ADDENDUM #3

30 July 2012

RE: Eli Whitney CTHS
Additions & Renovations Project
71 Jones Road
Hamden, CT 06514
Job Nos.: Department of Construction Services – BI-RT-837 / Antinozzi Associates - 04210

FROM: ANTINOZZI ASSOCIATES, P.C.

SEPERATOR INSTALLATION RECORD

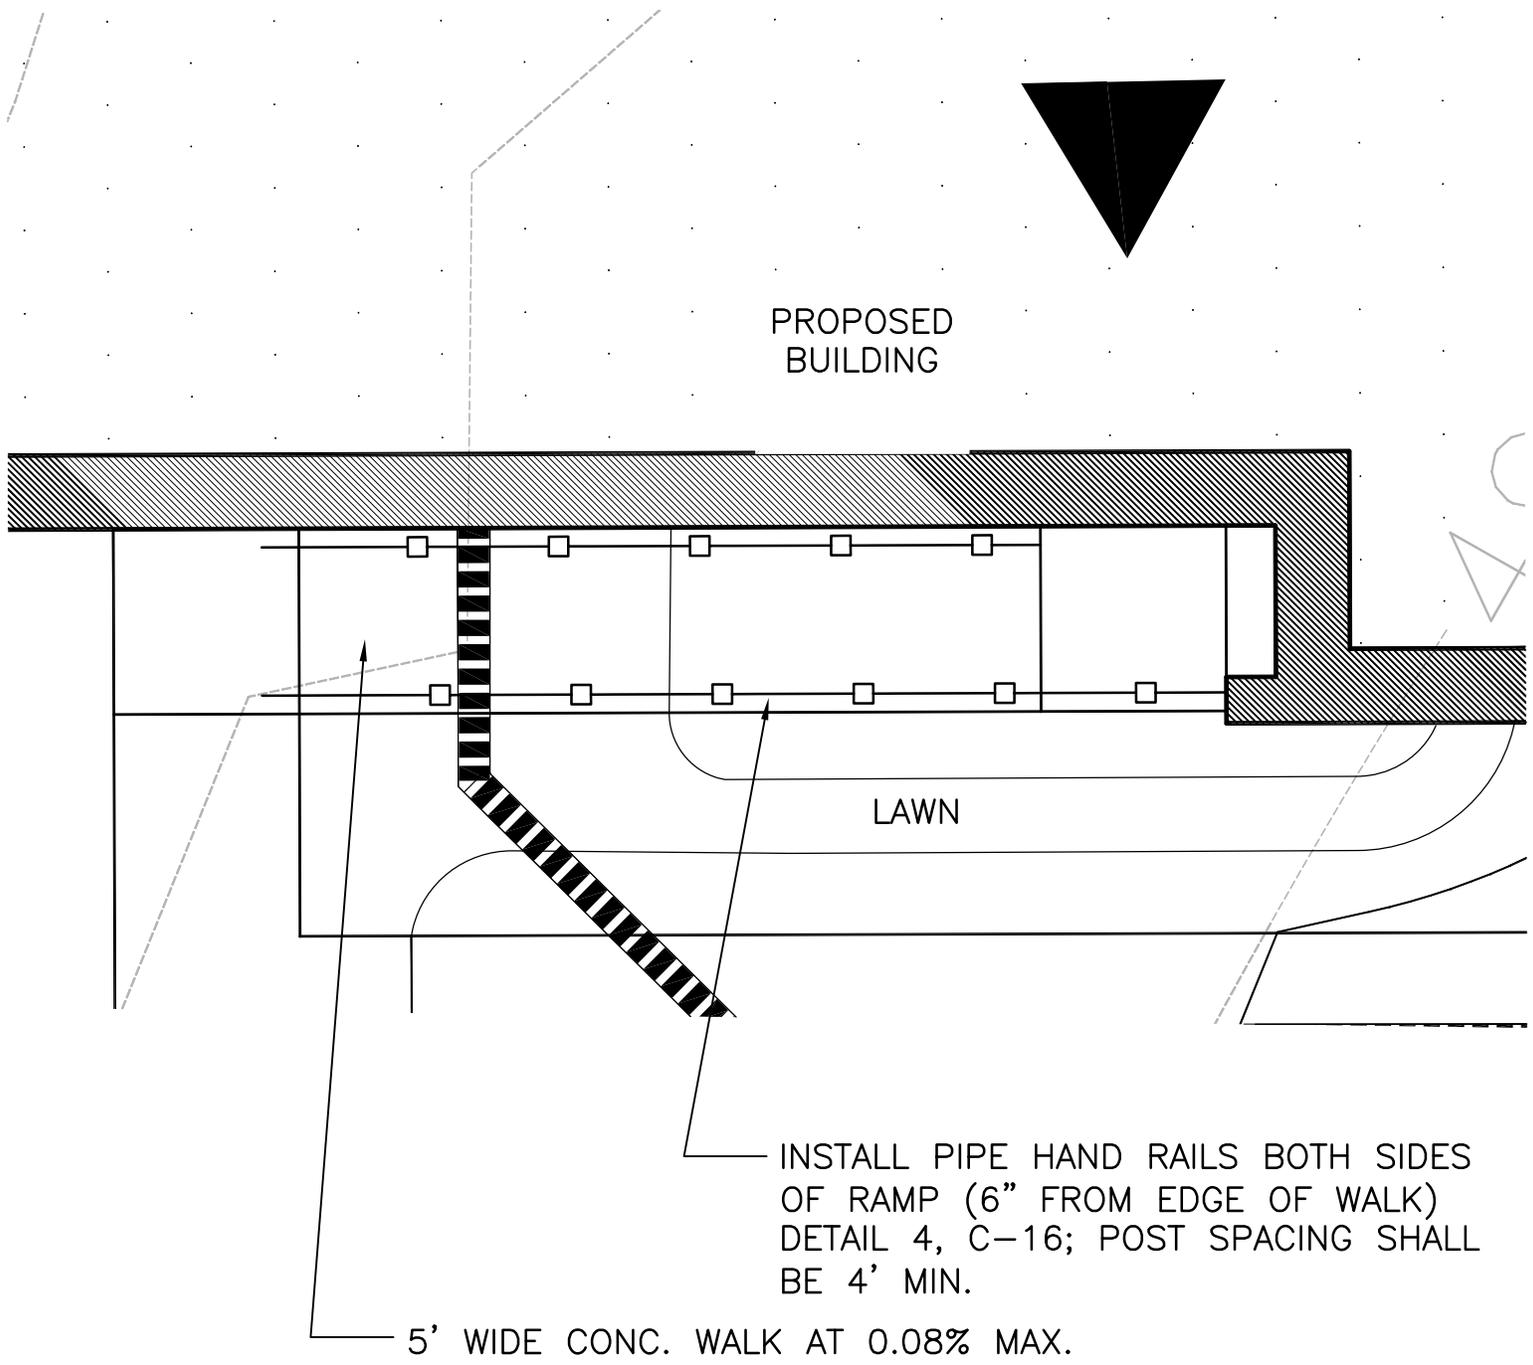
- 3) **Question:** *Sheet C-2 indicates to remove a below ground oil separator tank on the project west side of C Wing. Does this tank contain waste oil from the existing automotive garage? What is the size of the below ground oil separator tank?* **Answer:** See specification section 003124. Tank is stated to be a 550 gal. waste oil tank. Refer to Environmental Site Assessment - Phase 1 and other supplemental information in the project documents for further information.

**CONCRETE RAMP DETAIL
RFI 0.026**

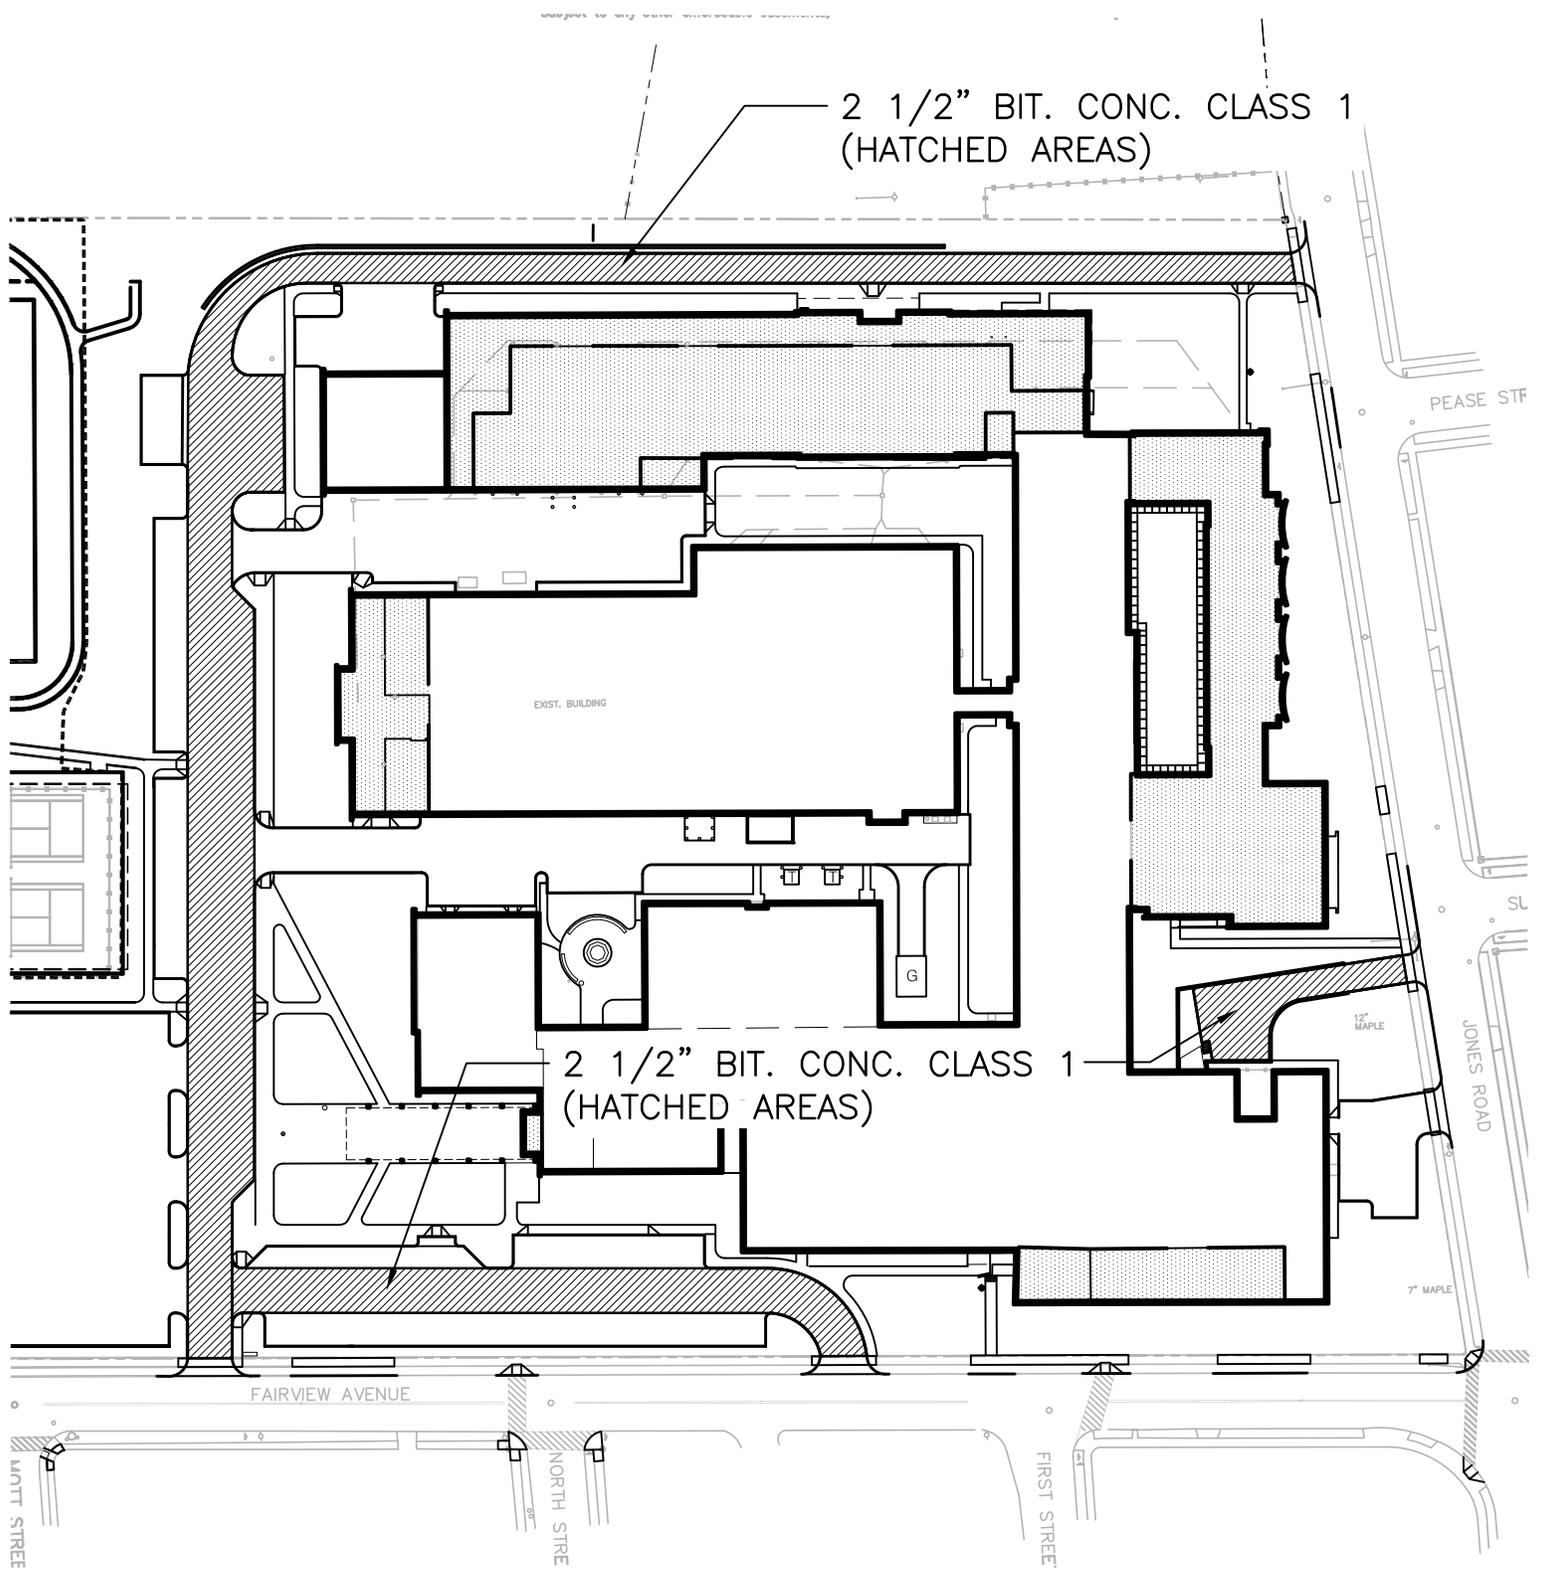
- 5) **Question:** 1. Please provide a detail for the proposed 20' long concrete ramp with railings noted on drawing C-3. 2. There is a concrete platform at the east side entrance to C Wing. Concrete stairs are shown due to the grading requirements (details 3, 4 on C16). Should there also be a retaining wall with railings? **Answer:** 1. Sketch SK-0.026 is attached detailing ramp. Also see Plan 1 Sheet A-105.1, and Elevation 6 on Sheet A-307. 2. A retaining wall will not be necessary. A 2:1 lawn slope is to be provided between the concrete platform and the bottom of steps.

REF. DWG: A-923 (PART OF ADDENDUM - 03)

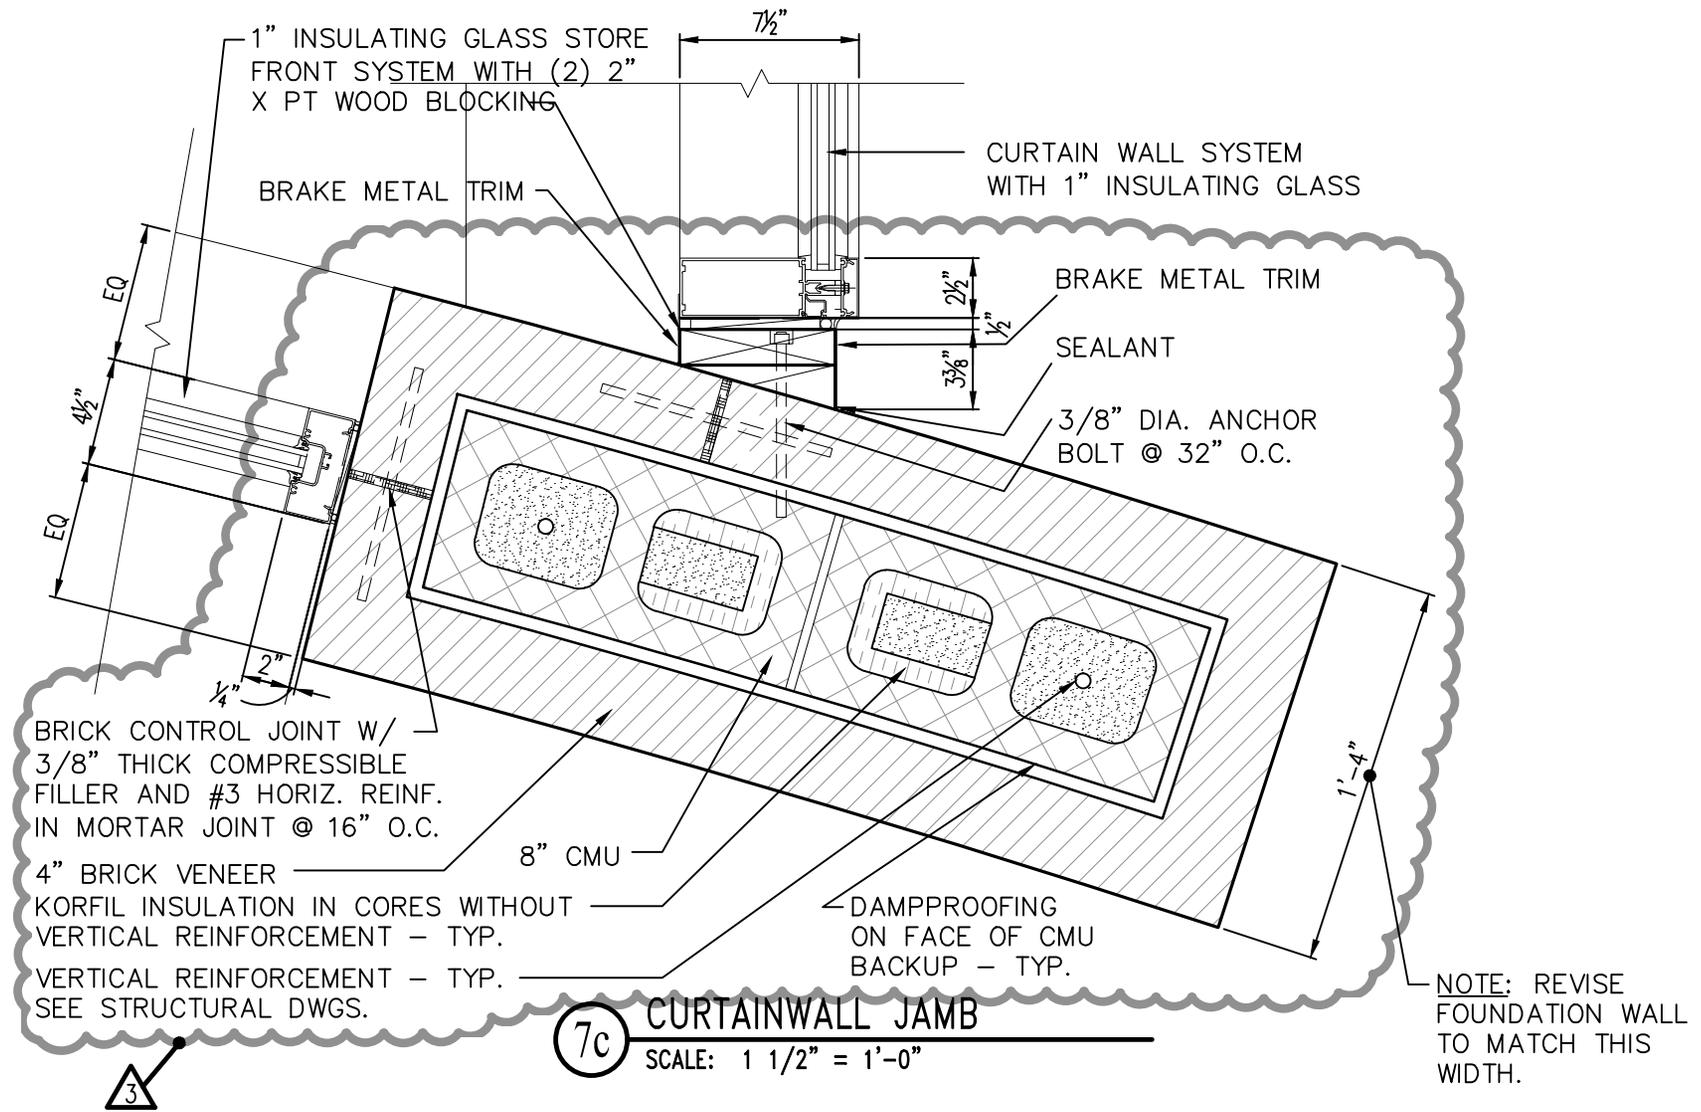
- b) **Question:** *Specification section 085113, subsection 2.1, item A indicates that the aluminum windows basis of design is the Winco model 1450H; however the aluminum window details on sheet A-922 and A-923 show a 4 - 1/2" deep storefront system which is different from the specified model. Please specify a different aluminum window model or update the window details to match the specification.* **Answer:** Insert the following general note on sheets A-922, A923, and A-924, "All Aluminum Window Details shall be 4" deep frames in lieu of the 4-1/2" frames shown."
